Appendix M2
Road Safety Audit
- Stage 1

Jacobs Engineering Ireland Limited

Figure 2.2 Pembroke St/ Leeson St Junction

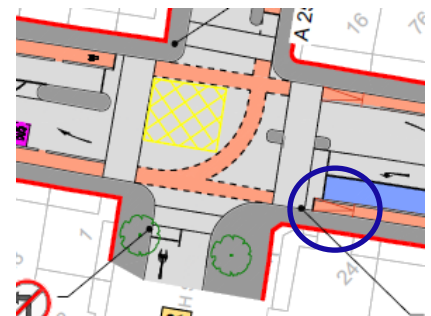
The Design Team should ensure a consistent approach to the location of the transition from cycle track to cycle lane on approaches to junctions, by setting the ramp back in accordance with the National Cycle Manual.

Figure 2.3 N11 Stillorgan Rd / Priory Dr / Old Dublin Rd

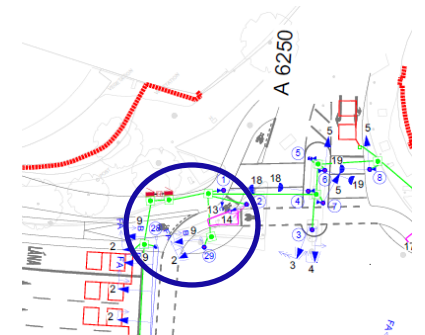
The Design Team should ensure cycle signals and associated stop lines are located in such a way not to cause confusion.

Figure 2.4 Greenfield Pk/ Nutley Lane/ Stillorgan Rd

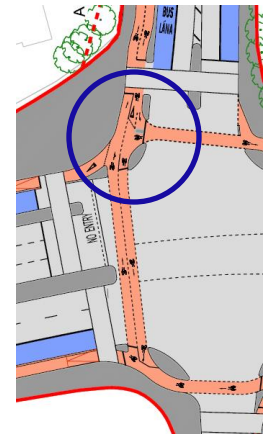
The Design Team should ensure there is sufficient stacking room for future level of cyclists need.

Figure 3.2 Wilton Terrace

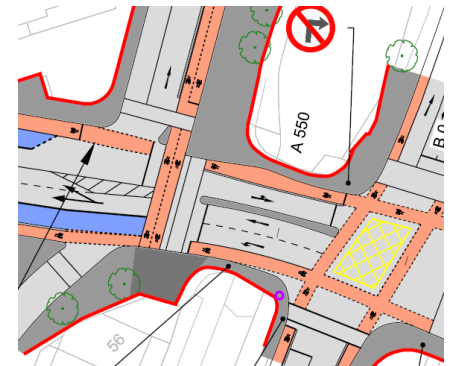
The Design Team should provide appropriate road markings to indicate the direction of travel.

3.2.1	Yes	Yes	These have been added for the two-way cycle track on Wilton Terrace.	
3.2.2	Yes	No	This area is noted as a heavy conflict point between cyclists and pedestrians already due to the heavy footfall along Leeson Street and the Canal walkway, the two-way cycle track along the Canal and Wilton Terrace, and the pinch point at the western access to the Canal path. We have introduced a Pedestrian Priority Zone at this point to impress on cyclists that they need to reduce speed and be aware of their interactions here, and to give priority to pedestrians.	Yes

Figure 3.3 Lack of a yield symbol

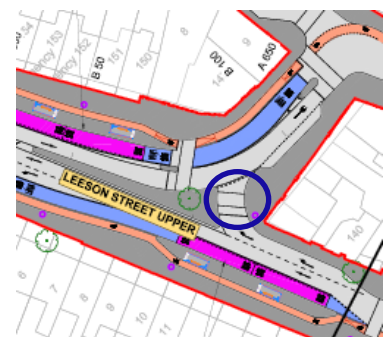
The Design Team should ensure suitable road markings are provided.

Figure 3.6 Proposed Table Ramp

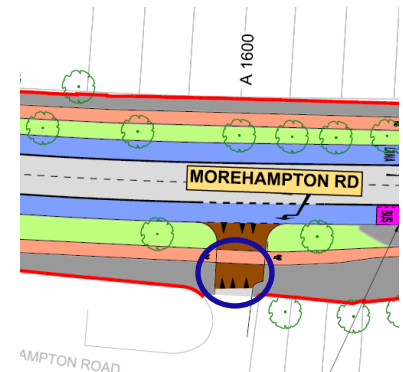
The Design Team should ensure the tabletop ramp is sufficiently wide to cover the pedestrian desire lines.

Figure 3.7 Existing In line crossing at Auburn Avenue Junction

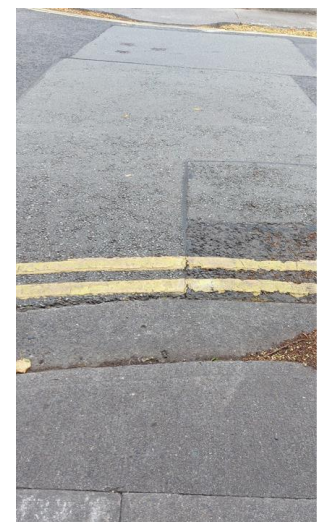
The Audit Team is concerned that the proposed cycle lane at chainage A2170 is of insufficient width and may lead to an increased risk of loss of control type collisions.

The Design Team should provide a cycle lane of sufficient width.

Figure 3.8 Entrance to Energia Pk

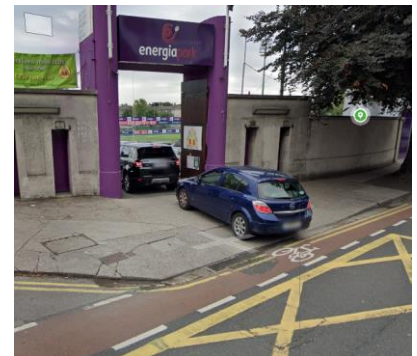
The Audit Team notes there is a vehicle access into Energia Park located at the proposed toucan crossing at Eglinton Terrace and Donnybrook Road which does not seem to be catered for in the design. There are concerns that this will lead to vehicle and Vulnerable Road Users conflicts.

The Design Team should revise the junction layout to incorporate this access.

3.7.4	Yes	Yes	The design has been revised to provide unimpeded access to this vehicle entrance, taking pedestrians and cyclists into account.	
3.7.5	Yes	Yes	The Accessibility Audit and Pavement Condition Report detail the areas in need of specific remediation, and the Detailed Design of the carriageway, cycle tracks and junctions will ensure that all drainage issues are resolved.

Figure 3.10 Existing off road cycle infrastructure at RTE access

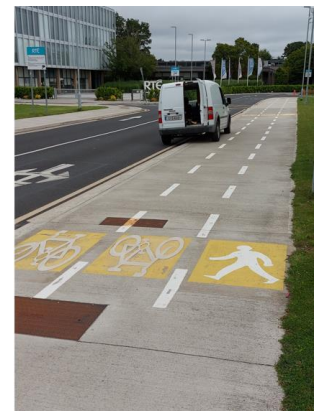
The Design Team should review the tie in and ensure it is appropriate to tie into existing infrastructure.

3.10.3	Yes	Yes	The issue with the off road cycle track is noted. This will affect cyclists exiting the Stillorgan Road and entering RTE. Recommendation is for the detail at this junction to be revised during Detailed Design to provide a tie into the two-way element of off-road cycle track within RTE lands.

Figure 3.12 Missing Yield Road Markings

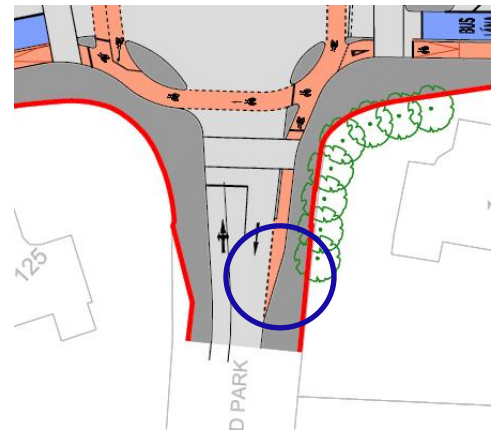
The Design Team should ensure that Yield road markings are provided to highlight road user priority.

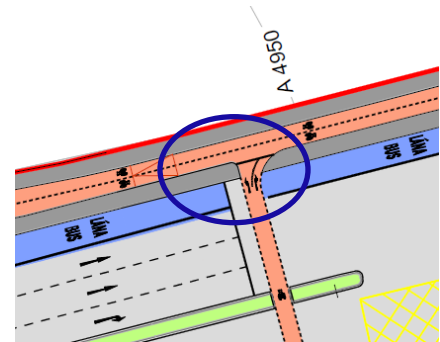
At chainage A4950, the Audit Team is concerned that the width of the cycle crossing (>7 lanes) in a single movement may result in insufficient time to cross the carriageway.

Figure 3.16 Inconsistent approach to pedestrian crossings

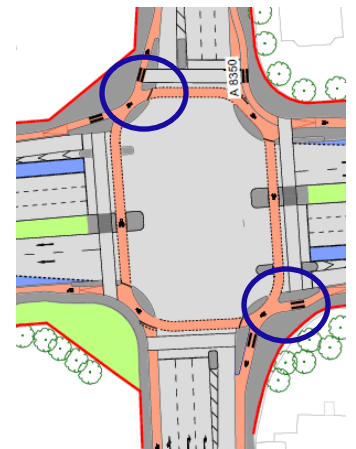
The Design Team should review this junction and provide a consistent approach with respect to pedestrian crossings on the carriageway and cycle track.

Figure 3.18 No Entry markings required

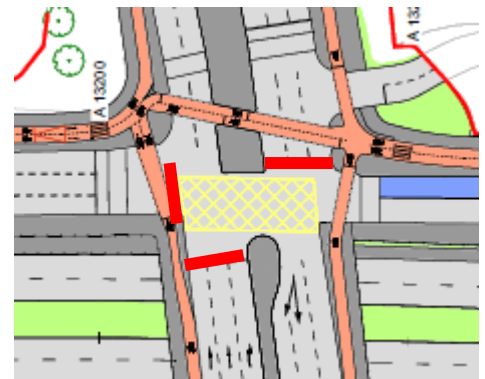
The Design Team should ensure there are appropriate marking in place to prevent unintended manoeuvres

Figure 3.19 Cycle Lane narrows

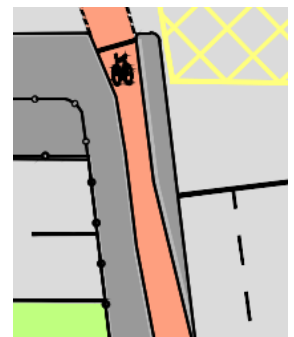
The Design Team should ensure there is appropriate space for cyclists on approach to the junctions.

Figure 3.20 Cycle Lane narrows

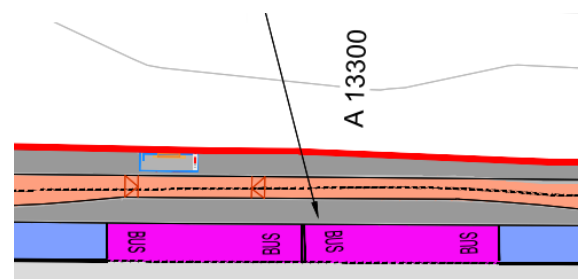
The Design Team should provide a cycle lane that is sufficiently wide to provide two-way flow.

Figure 3.23 Cycle Lane narrows

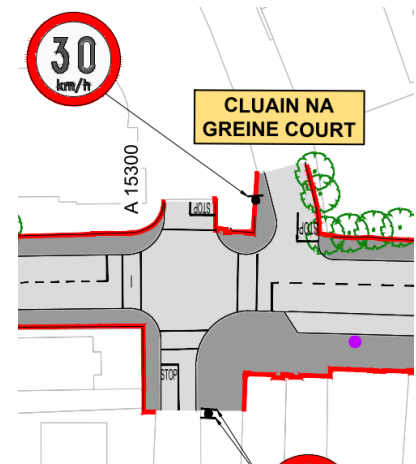
The Design Team should provide a yellow box or integrated, vehicle activated signals to allow motorists to egress Cluain na Greine Court safely.

Figure 3.25 Cycle Lane Integration

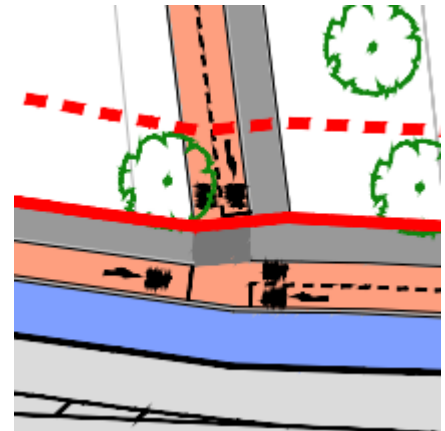
It is noted the proposed integration of new cycleway on the scheme with an existing offline cycle route at this location. The Audit Team are concerned about the potential for pedestrian and cyclist conflict at this location.

Figure 3.26 Footpath to shopping centre

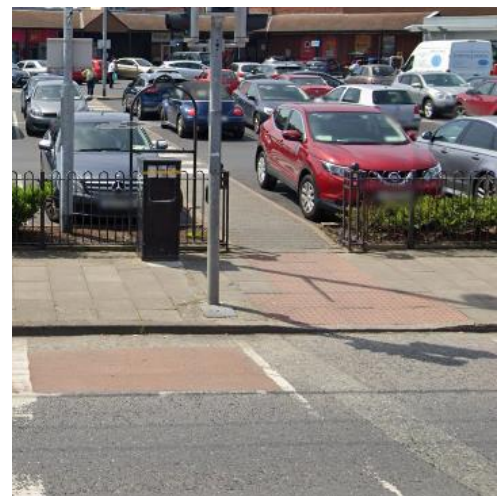
The Design Team should consider relocating the pedestrian crossing back to the existing location.

3.45.1	Yes	No	The relocation of the pedestrian crossing has been carried out to allow a number of wider scheme objectives to be met and has been considered in some detail. It also moves the crossing closer to the main Dwyer Park approach, and closer to the main Shopping Centre entrance off Castle Street.	Yes

Figure 4.1 Secondary signal

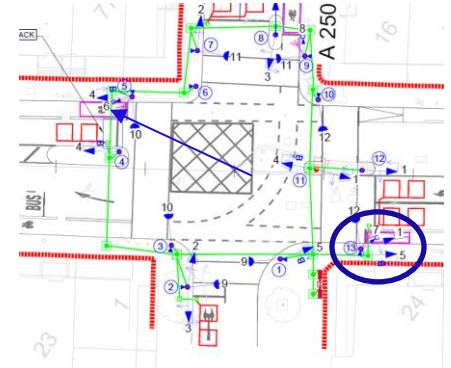
The Design Team should consider relocating the secondary signal to the proposed traffic island opposite the stop line.

Figure 4.4 Incorrect stick diagram

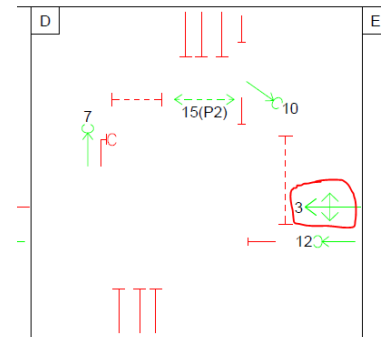
The design team should ensure the stick diagram is correct.

Figure 5.1 Lack of road markings directing buses

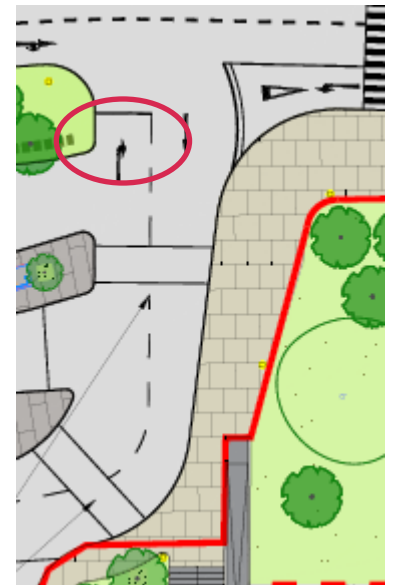
The Audit Team notes a lack of stop markings and stop sign for vehicle performing a right turn manoeuvre (Red Circle – Figure 5.1). There are concerns that vehicles exiting this development may not give priority to the main traffic arm.

The Design Team should ensure that 'STOP' road markings are placed in appropriate location at the junction.

Figure 5.3 Cyclist desire line

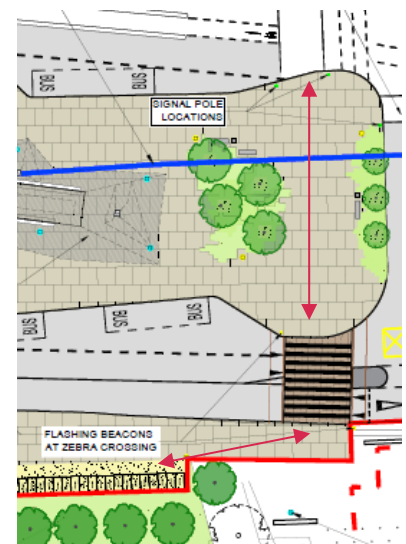
The Design Team should consider measures to segregate pedestrians and cyclists or ensure this shared space encourages low speeds as part of an urban realm design and that the needs of the visually impaired are considered.

Figure 6.1 No "STOP" road markings

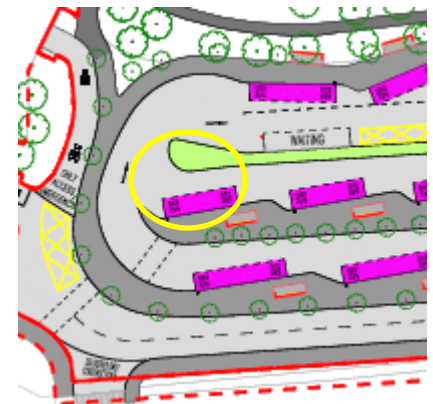
The Audit Team is concerned there is no Stop markings at the Northern side of the UCD Interchange (see Figure 6.1 No "STOP" road markings

Figure 6.2 Risk of Pedestrian/ Cyclist conflicts

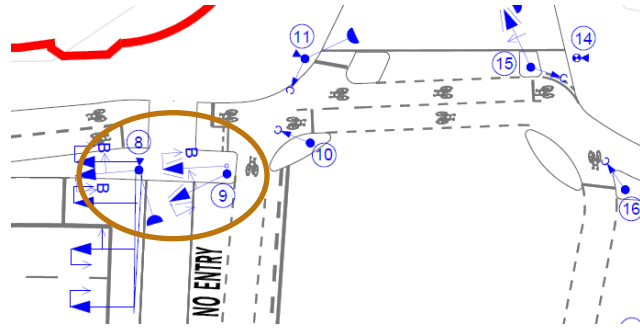
The design team should include signals to allow pedestrians cross the two-way cycle lane

Figure 6.3 Facilities for cyclists

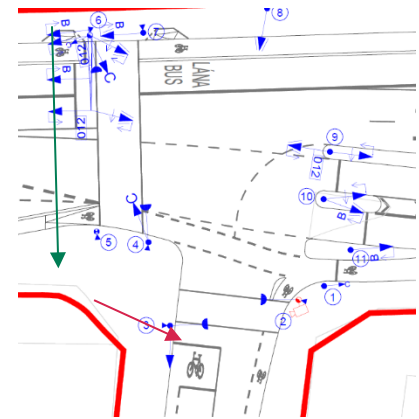
The design team should consider provision of a Toucan Crossing across Eglinton Rd.

6.15.1	Yes	Yes	The crossing over Eglinton Road can be converted to a Toucan.	
6.16.1	Yes	Yes	Dashed line to be added to phasing diagram	
6.16.2	Yes	Yes	The crossing on the north side can be converted to a Toucan with appropriate lead in ramps added.
